**Addendum No. 3**

**Final Environmental Impact Report  
for Metro Gold Line Foothill Extension - Azusa  
to Montclair (SCH 2010121069)**

**Evaluating Minor Design Changes of the Project  
Azusa to Montclair**

Metro Gold Line Foothill Extension Construction Authority  
March 2016

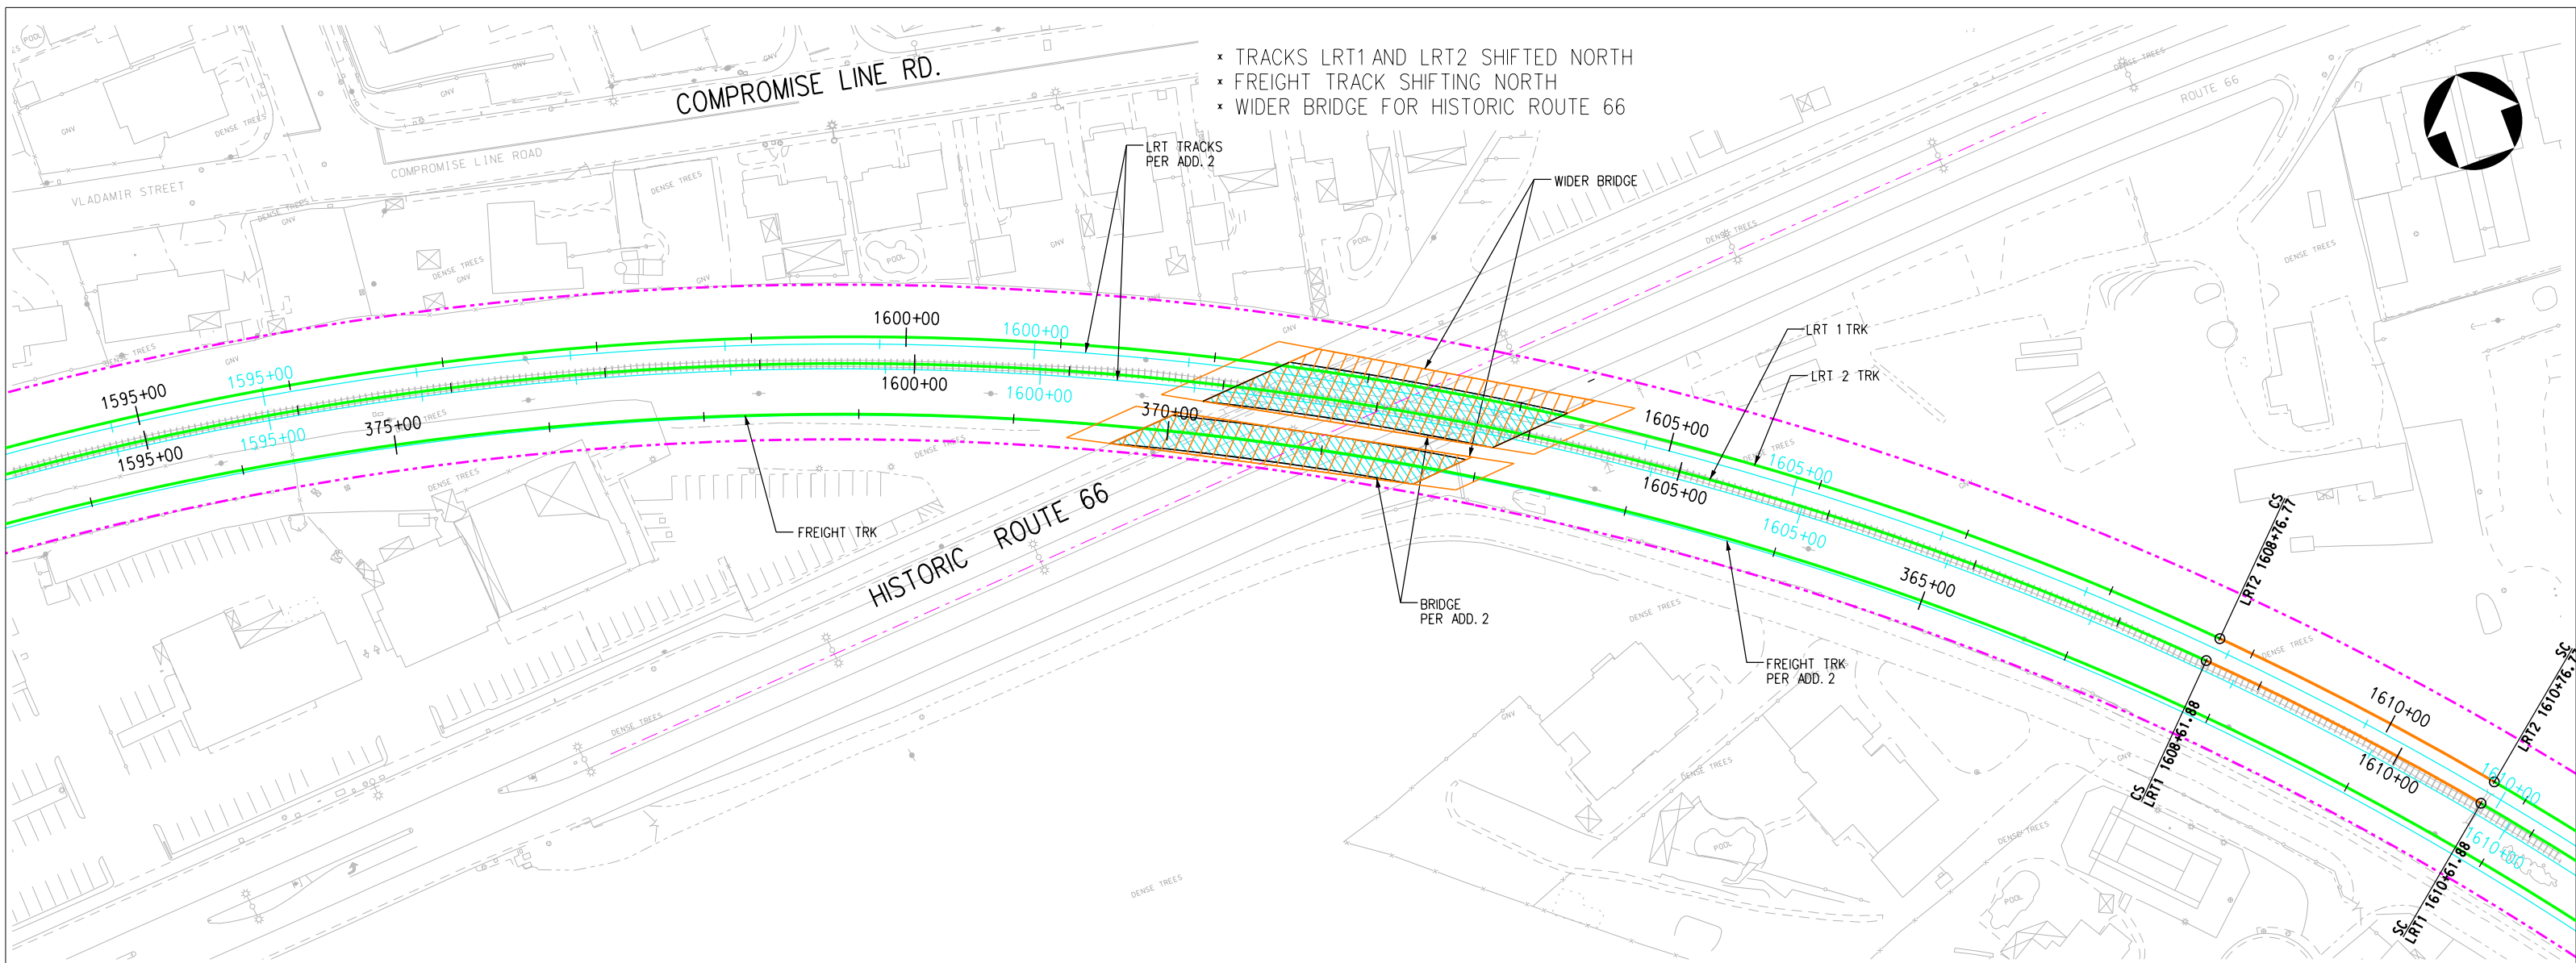
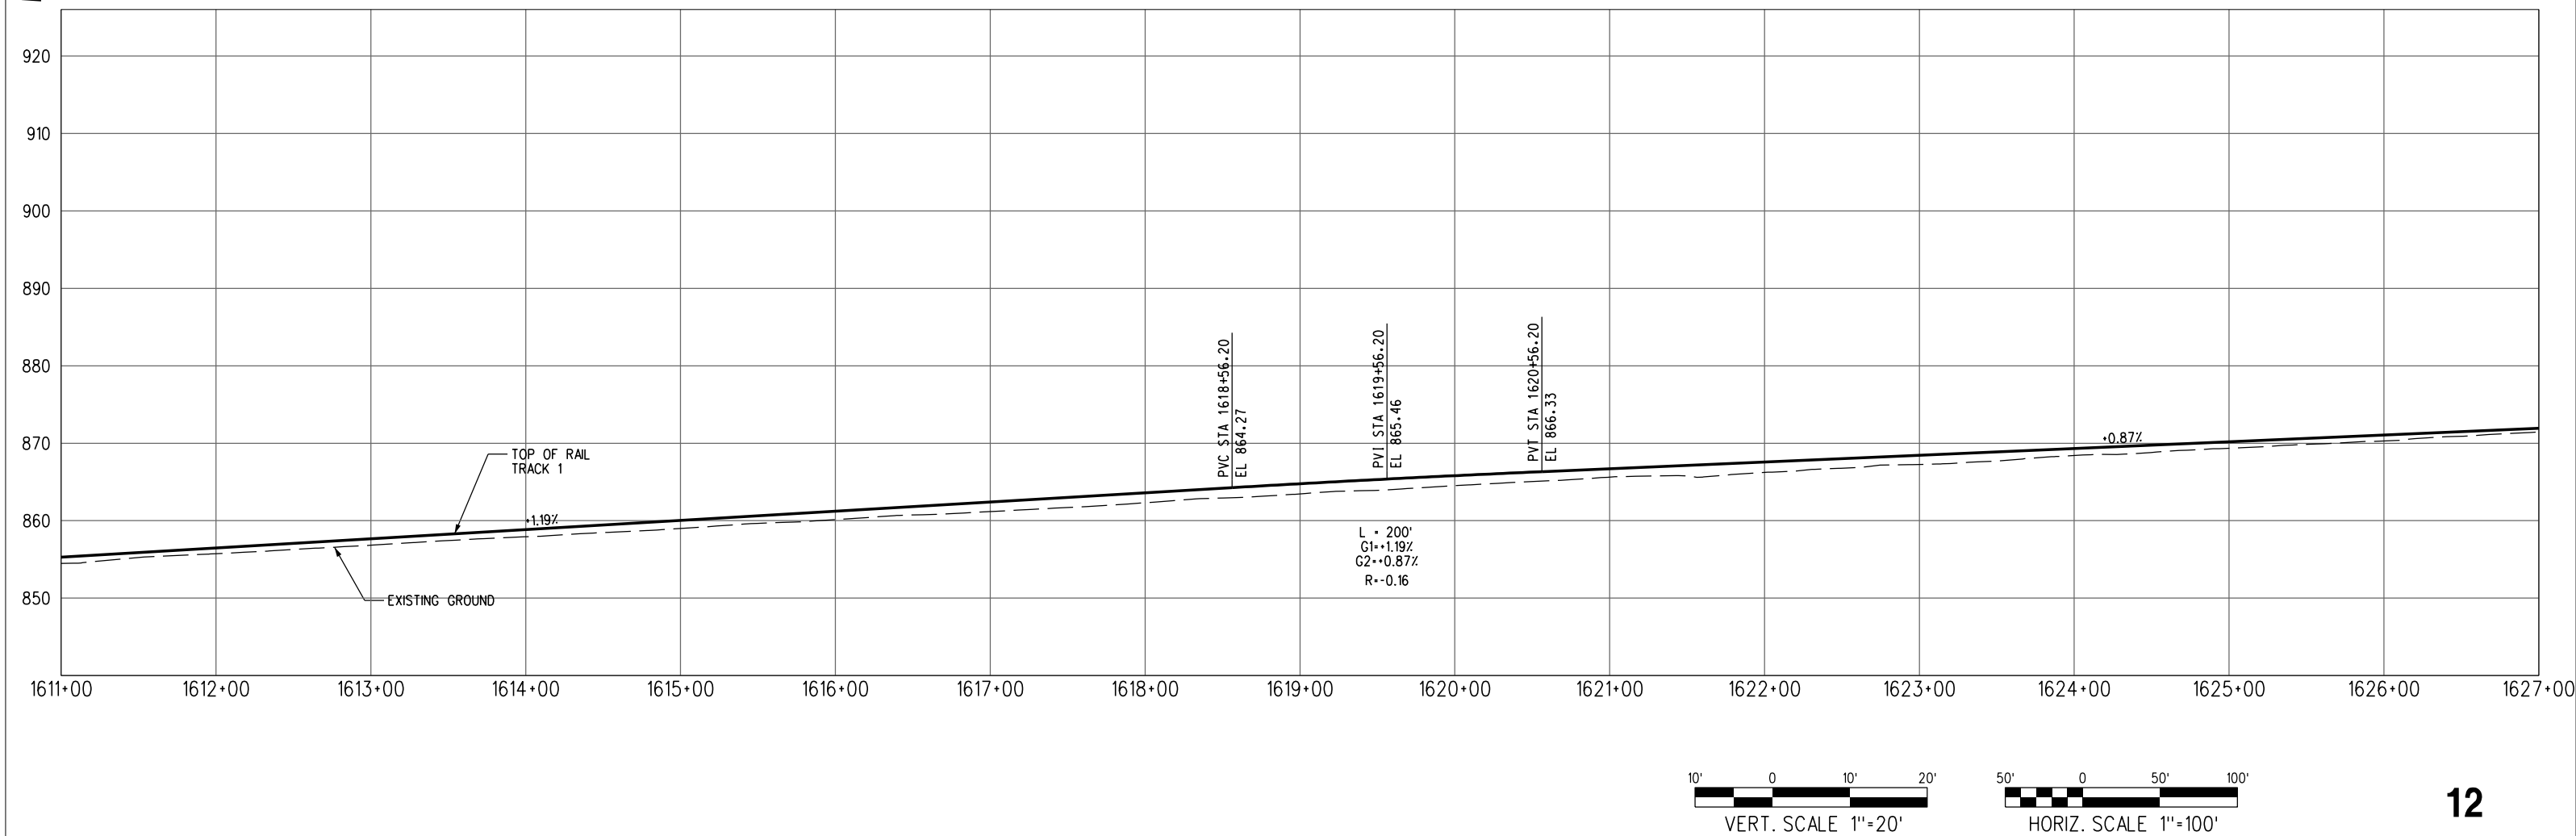
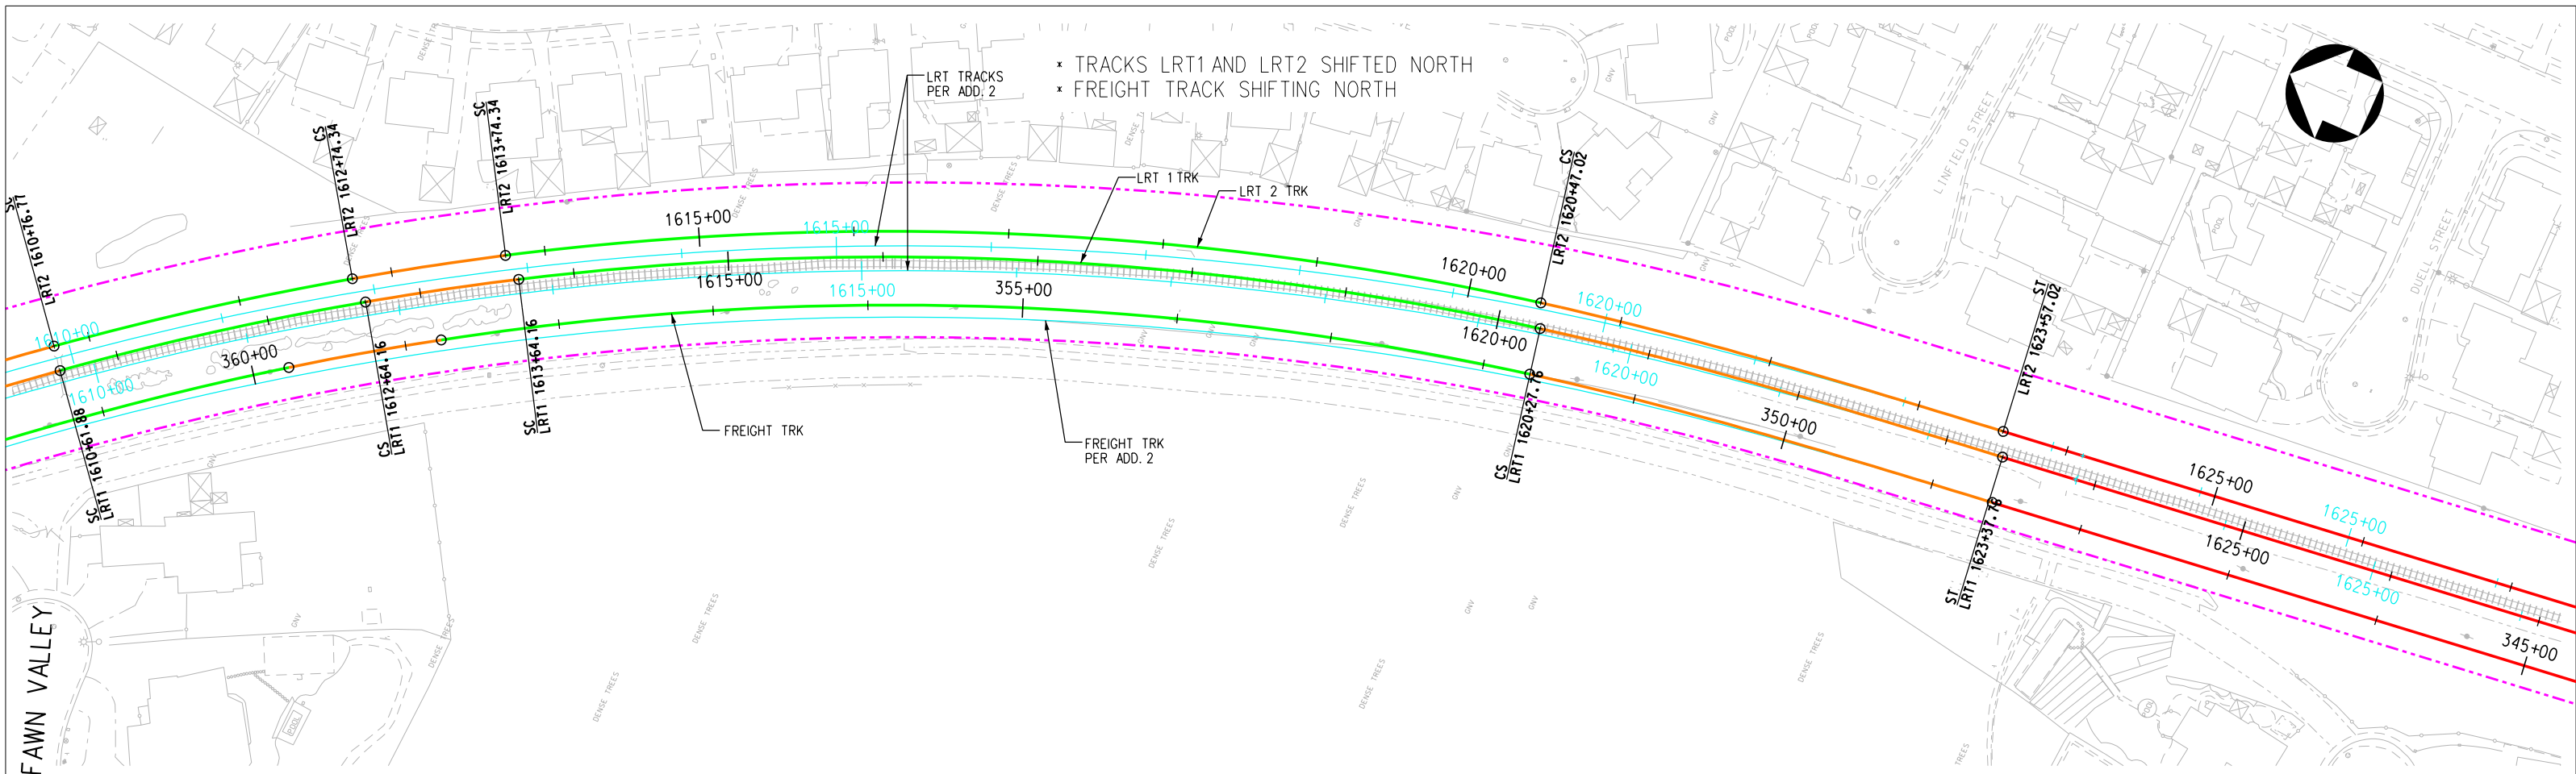
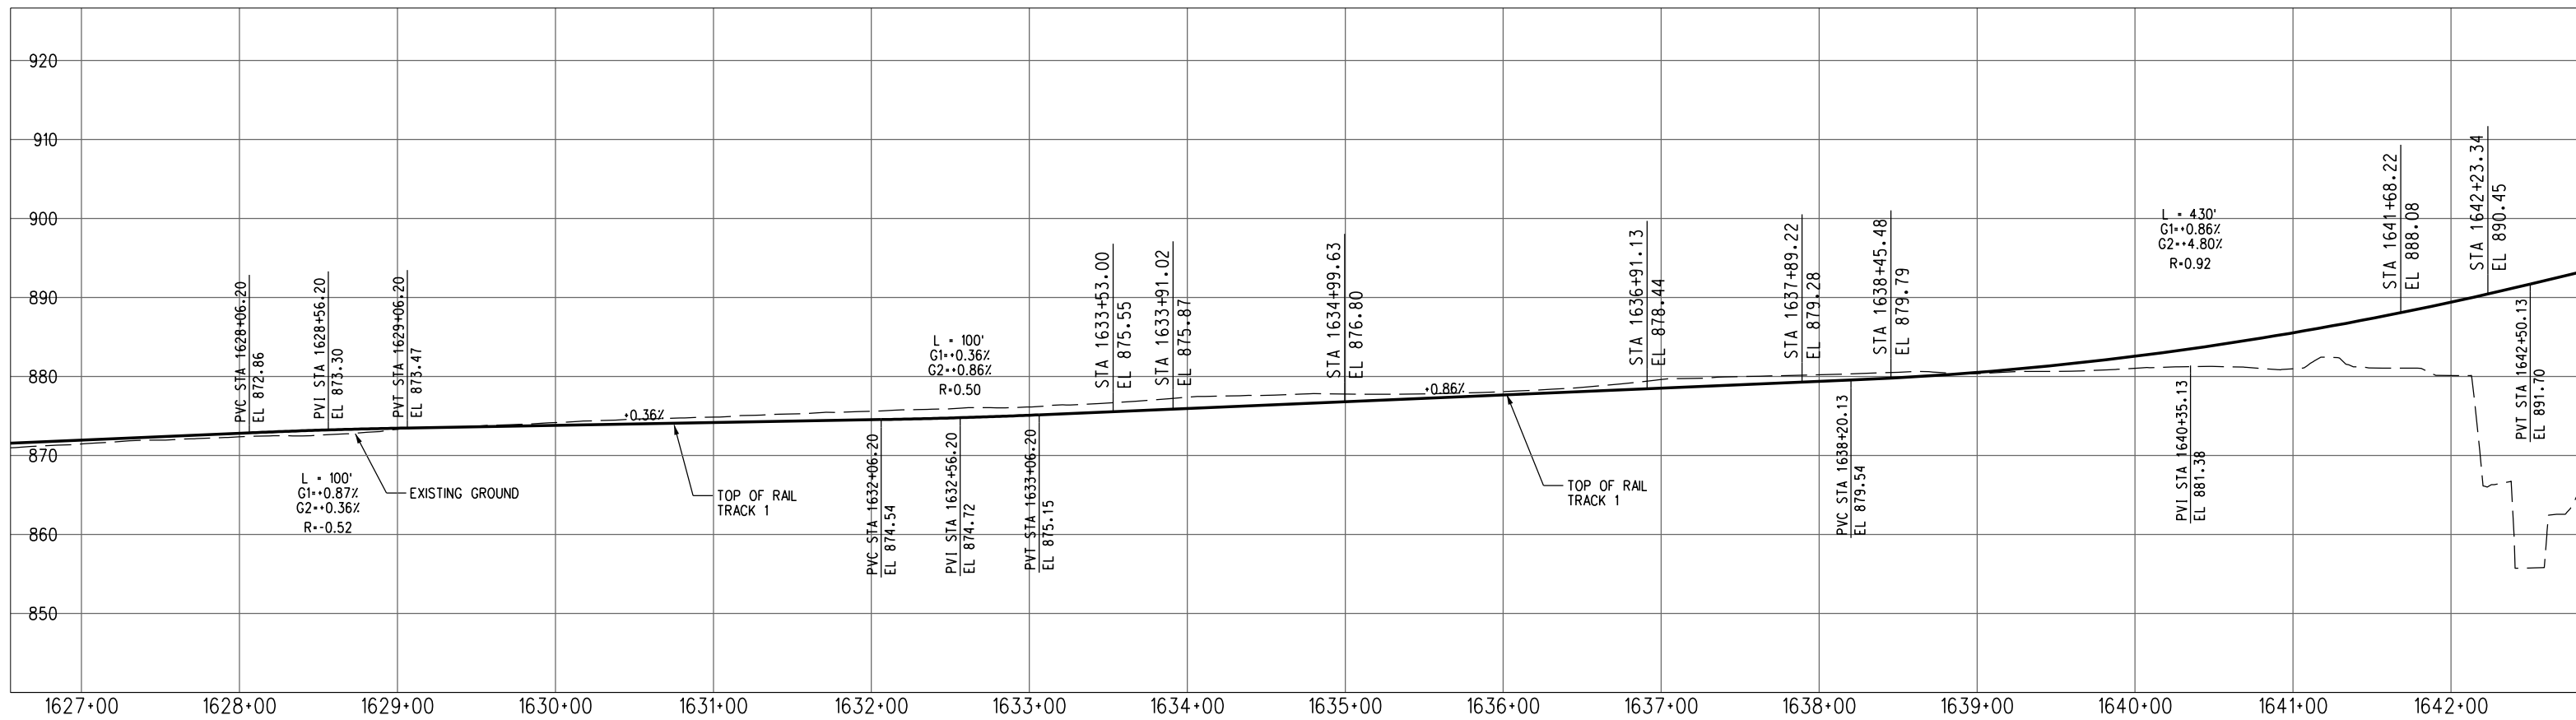
- \* TRACKS LRT1 AND LRT2 SHIFTED NORTH
- \* FREIGHT TRACK SHIFTING NORTH
- \* ADDED 2 NEW #20 CROSSOVERS
